# REGIONAL REVIEW FINDING

ARC REVIEW CODE: R1902051

**Name of Proposal:** 75 South Logistics Center (DRI 2867)

DRI SITE PLAN  
**75 SOUTH LOGISTICS CENTER**  
CITY OF LOCUST GROVE, HENRY COUNTY, GA  
JANUARY 16, 2019

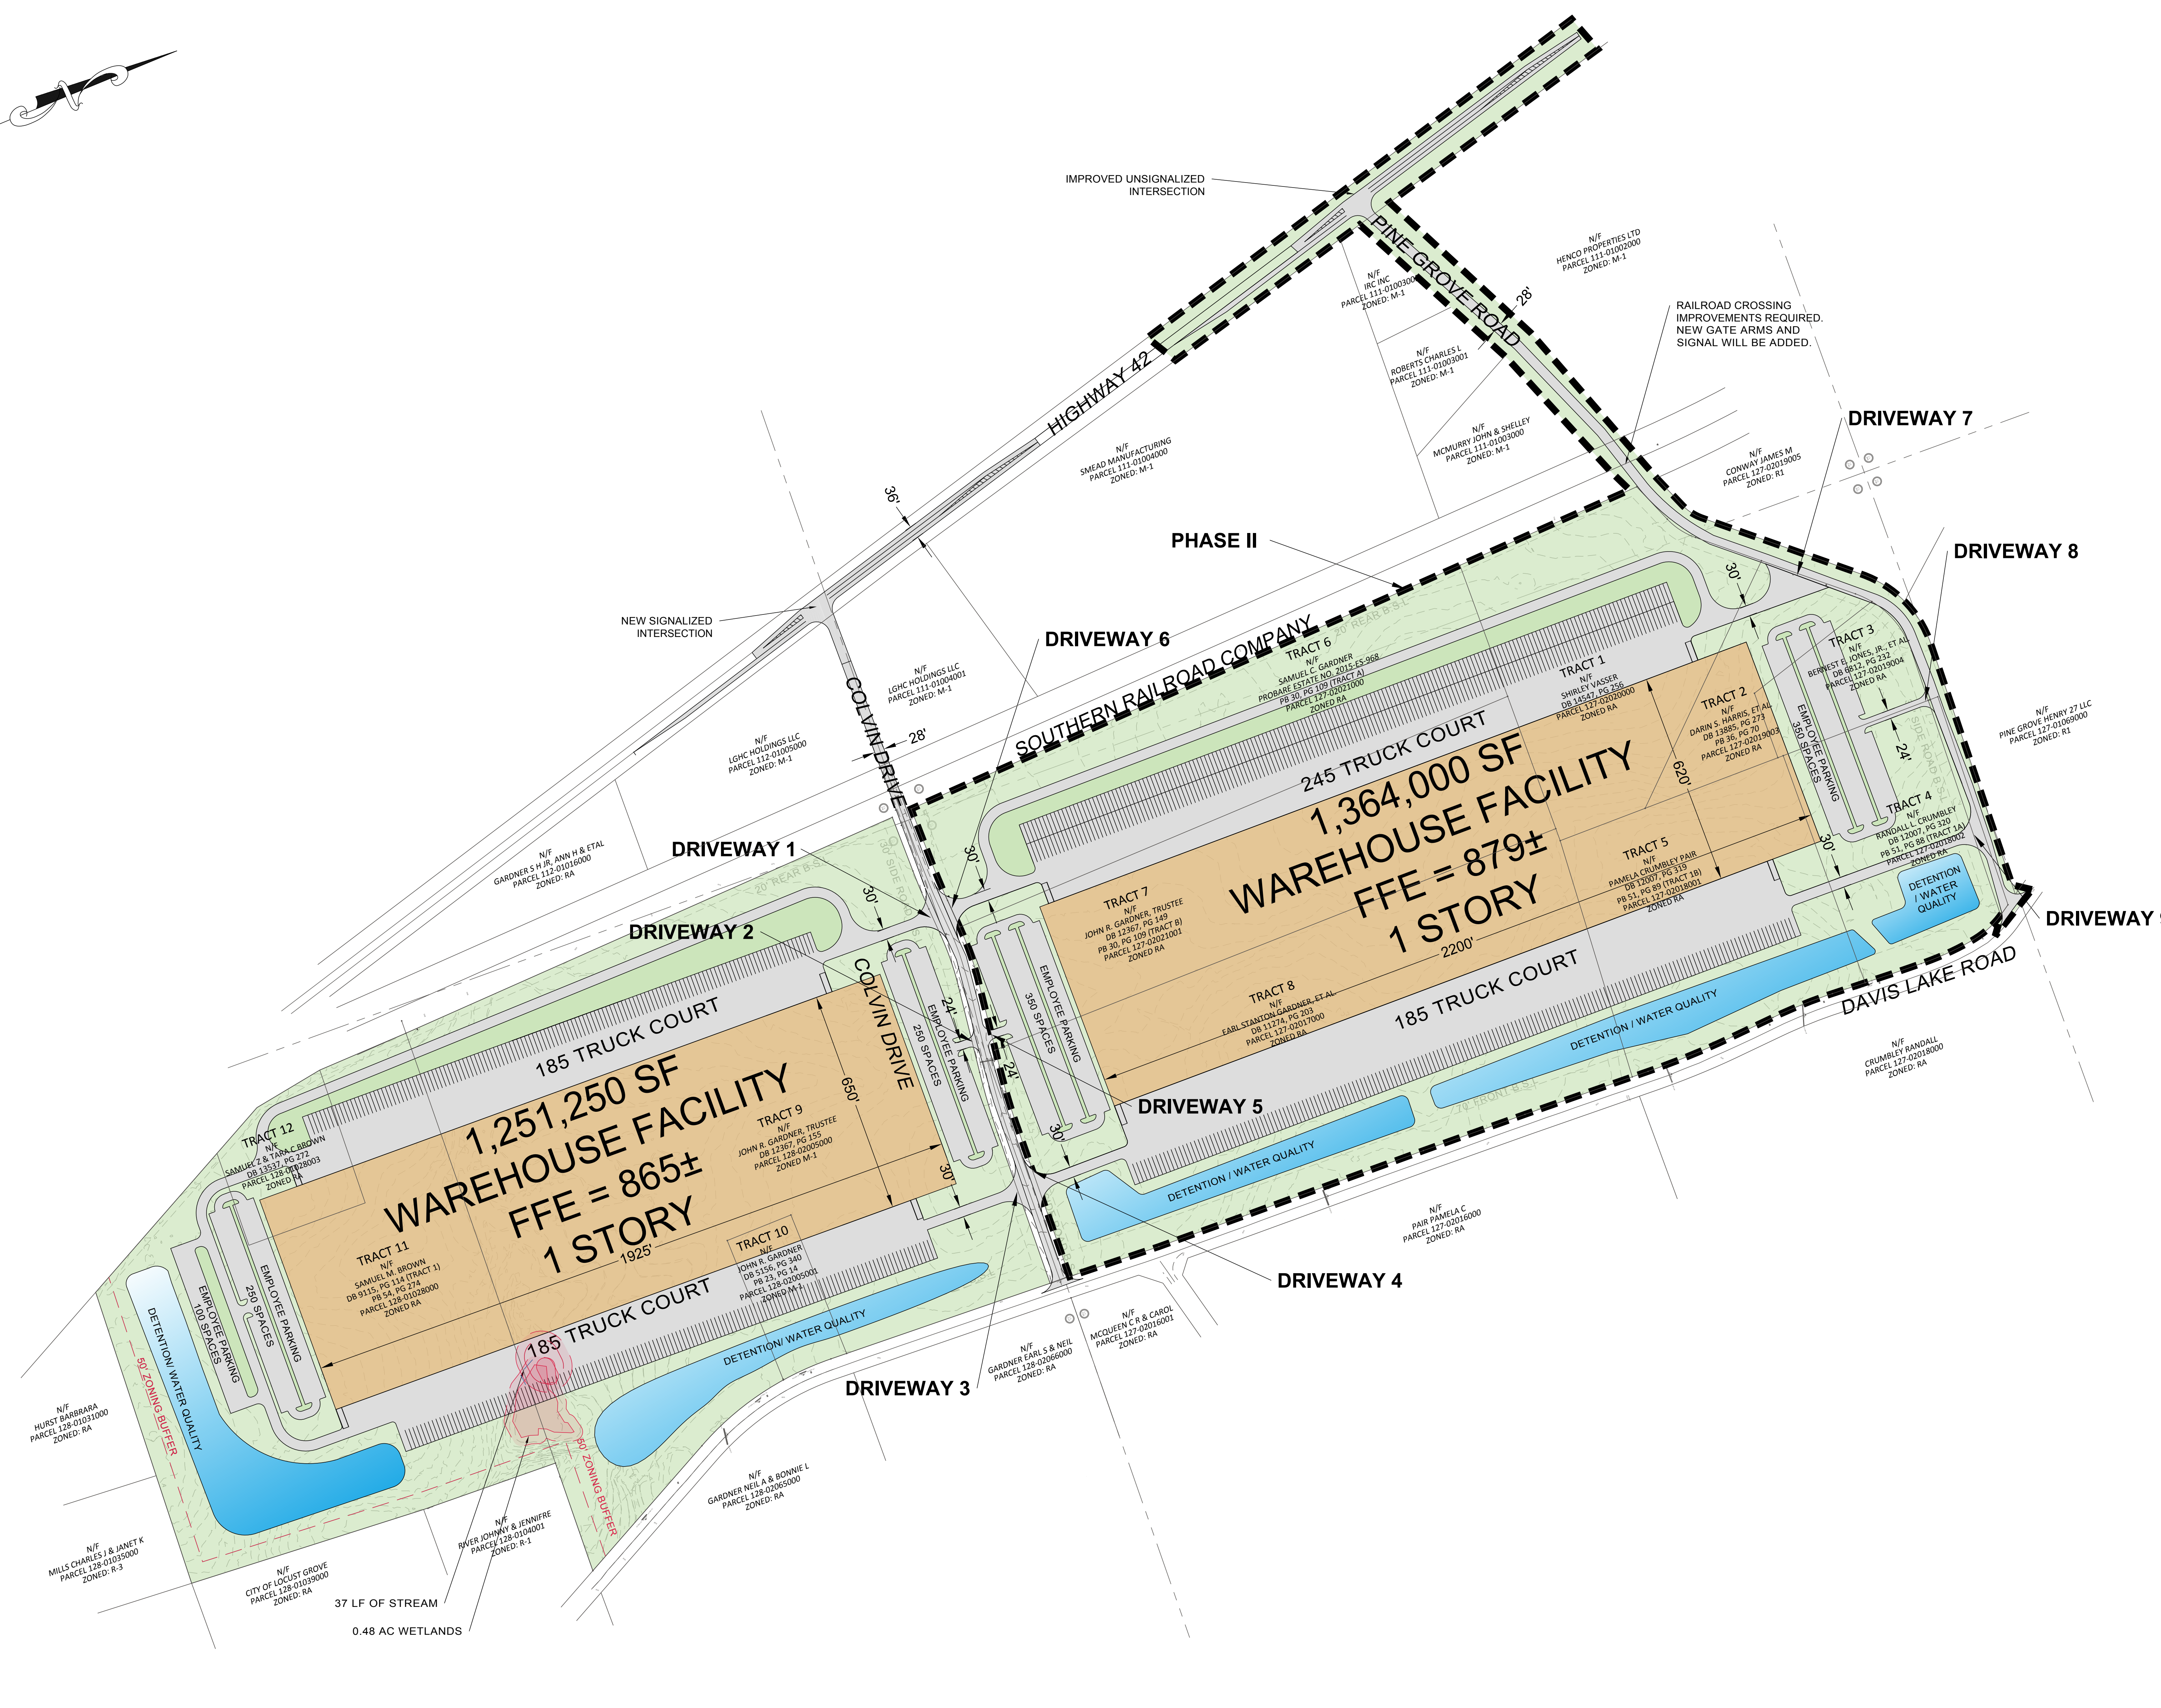
In addition, the development team should ensure that Pine Grove Road is improved to accommodate the DRI project traffic, especially trucks, as shown on the submitted site plan. These improvements also include upgrades – at minimum, a new signal and gate arms – to the railroad crossing on Pine Grove Road. Finally, the

applicant/development team, City of Locust Grove, Henry County DOT and GDOT will need to continue coordination regarding the planned improvements, shown on the site plan, to the intersections of both SR 42 at Colvin Dr. and SR 42 at Pine Grove Rd.

- As mentioned above, continued coordination will be required regarding planned improvements, shown on the site plan, to the intersections of SR 42 at Colvin Dr. and SR 42 at Pine Grove Rd. GDOT District 3 comments, received during the review, indicate that the new signal at SR 42 and Colvin Dr., proposed by the DRI applicant, will not meet signal warrants and therefore will not be signalized.

We have reviewed the DRI report. The only comment we have is that on the layout it shows a new signalized intersection being installed at the intersection of Colvin Dr. and SR 42. This intersection will not meet signal warrants and therefore will not be signalized. We recommend removing this note from the layout.
